Customer Service Bulletin

SLM Electronics, Inc., Saint Louis, Missouri, USA

#CSB0019

The purpose of this CSB is to provide guidelines for recognizing the intentionally reversed wiring and changing this wiring to the correct configuration when replacing the affected high frequency drivers.

Figure 2: Incorrect wiring of the HF terminals:

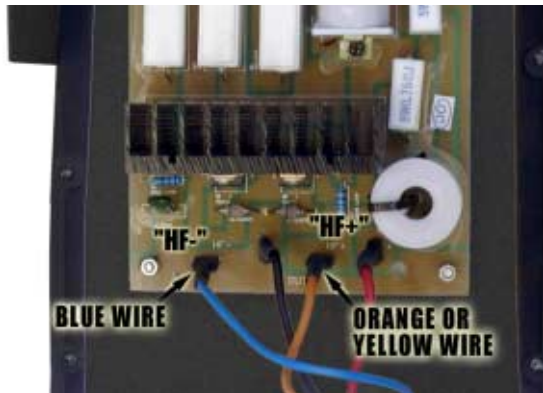
The wiring from the high frequency driver to the crossover in *some* PSM12 and PSM15 speakers was intentionally reversed to obtain the correct phase for the output from the driver. The affected speakers have serial numbers that are within the ranges stated above. The reversed wiring affects the polarity of the connection only and does not represent a safety issue.

(2) Inspect the wiring connections to the "HF+" and "HF-" terminals on the crossover. If the wiring is as shown in [Figure 2](#), disconnect the blue and orange (or yellow) wires from the HF terminals.

(3) Connect the orange (or yellow) wire to the "HF-" terminal and the blue wire to the "HF+" terminal as shown in [Figure 3](#).
